Response to comments on 'First In Situ Measurements of the Prototype Tesseract Fluxgate Magnetometer on the ACES-II Low Sounding Rocket' by reviewer #2 on February 15th 2024

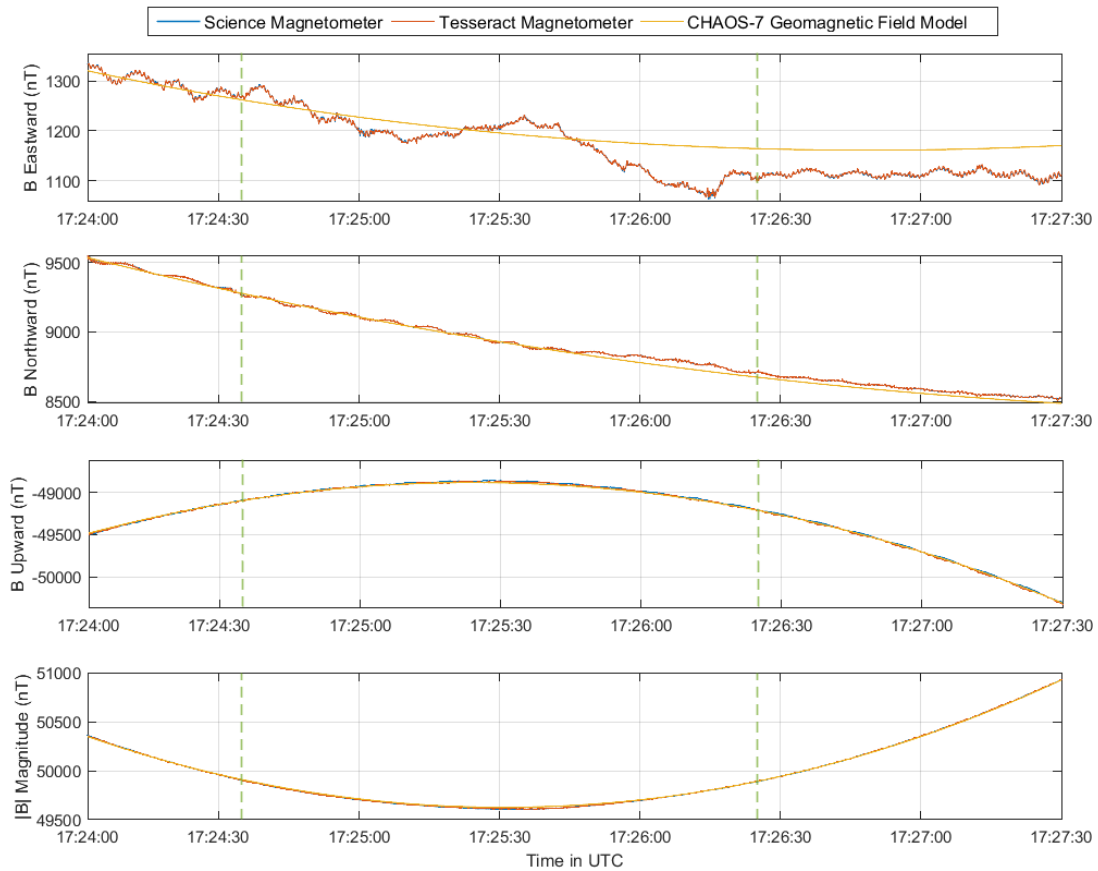
4. It is said that a quiet period between 17:24:00 and 17:24:30 was used for the in-flight calibration, but not the entire 30 seconds are shown in Figure 6. What do the data look like before the “quiet period”?

5. The measured and the modelled field obviously agree to within 25 nT RMS outside of the scientifically interesting period. What is the standard deviation of the difference within the mentioned crossing of the active auroral arc? The plots in Figure 6 do not indicate a big difference between the two phases.

The reviewer points out that Figure 6 does not show the entire quiet period and cuts off the plot too early. We thank the reviewer for bringing this error to our attention. The new Figure 6 in the revised manuscript plots the magnetic field starting at 17:24:00 UTC and shows the complete quiet area where the instrument was calibrated from beginning to end. The new Figure 6 is shown below and has also been incorporated into the revised version of the manuscript:

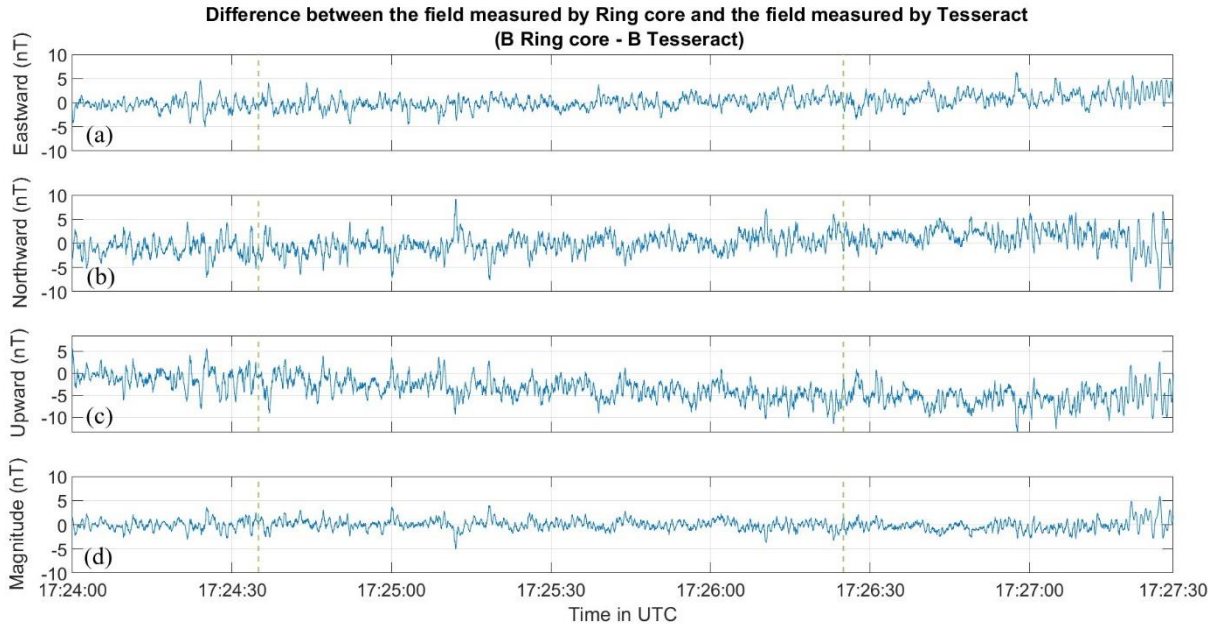
6. The performance discussion would benefit from plotting the difference between the prototype and science magnetometer to deepen the demonstration of the good match. The mentioned alignment mismatch between the two sensors could be calibrated based on the flight data which would further reduce the reported RMS deviation.

7. A comparison of the filtered data from both magnetometers would show that also the actual science event was measured correctly by the prototype sensor.

We agree with the reviewer's assessment that plotting the difference between the field measured by Tesseract and the field measured by the Ring core science magnetometer would be

illustrative in demonstrating the agreement between the sensors and help to reinforce the main result of the paper: that the Tesseract magnetometer performed as expected as a functioning magnetometer over the course of the flight. We have added a new Figure 7 which plots the difference between the sensor's measurements in each axis on line 286:

We agree with the reviewer that a plot showing the agreement of the magnetic field measured by Tesseract and the magnetic field measured by the science magnetometer in the science region would demonstrate that the science region was measured correctly by the prototype. A Figure 7 has been added, which shows the difference between the field measured by the Tesseract and the field measured by the ring core. The region of data bounded by the green dashed lines shows the difference of the fields measured by the two sensors in during the science event.

Line 283 now reads: "The Tesseract and Ring core measured the same field in the region of auroral activity (bounded by green dashed lines in Figure) to within 5.53 nT RMS in all three axes."
